UNITED STATES PATENT AND TRADEMARK OFFICE

10/814,136

Office Action Summary

DETAILED ACTION

Fig. 4

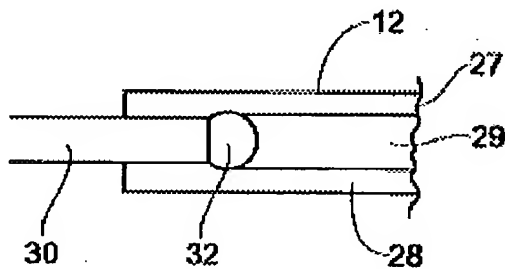
As to claim 1, Henneman discloses a connection structure between optical fibers, comprising: a substrate a plurality of optical fibers, 30 and 29, each having end surfaces; a base member [portion below 32] provided over the substrate [col. 2, lines 10-55]; and a connecting part, 32, provided on a top surface of the base member and joined to each end surface of the plurality of optical fibers [col. 12, lines 3-68].
